Connection Check: Timing Requirements Baseline Text

Texas Instruments

IEEE802.3bt Task Force

May 2015

Connection Check: Timing Requirements

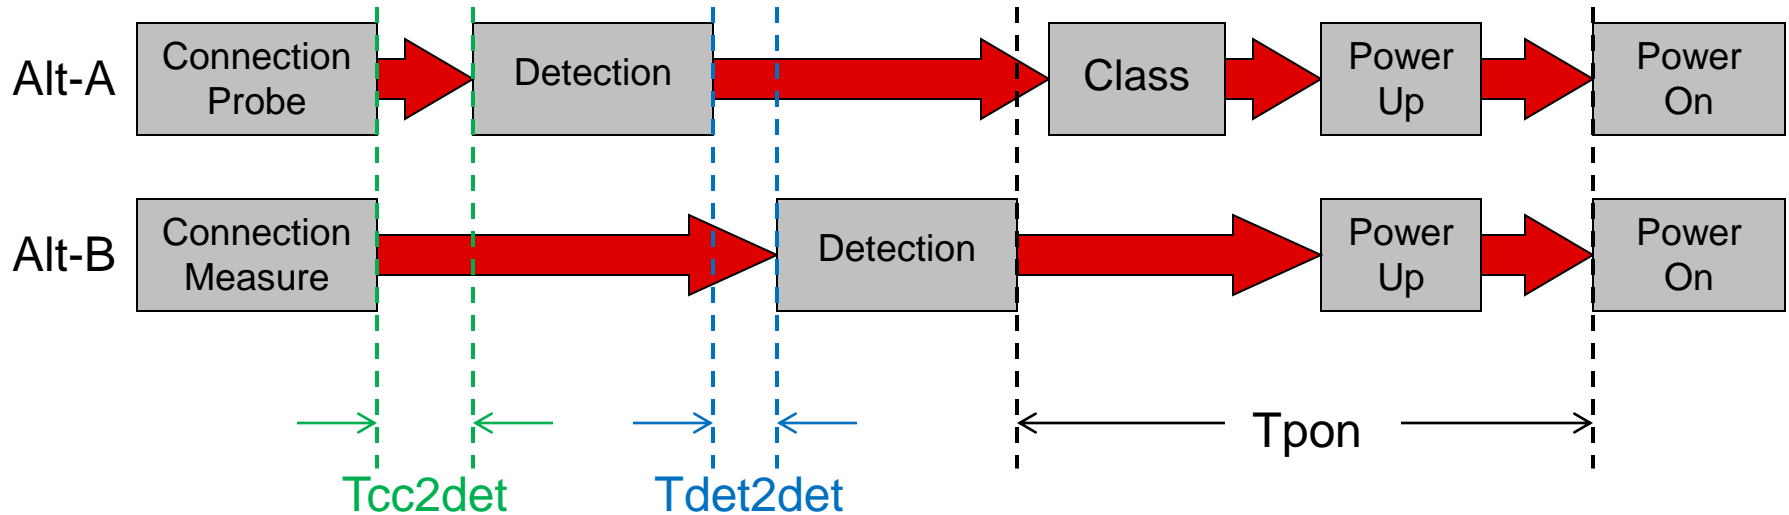
- The goal of the timing requirements for the connection check (and rest of the powering procedure) are to not allow gaps of greater than 400ms where a cable could be unplugged and another cable plugged in without the PSE recognizing it.
 - The T_{pon} requirement makes sure that a PD is powered within this 400ms limit from the end of detection.
 - There is now information gained during the connection check (as well as independent detections on each pair set) that must be “maintained” until the PD is powered.
 - “Maintained” means that we must ensure the load is not switched without the PSE restarting the connection check/detection/power up procedure.
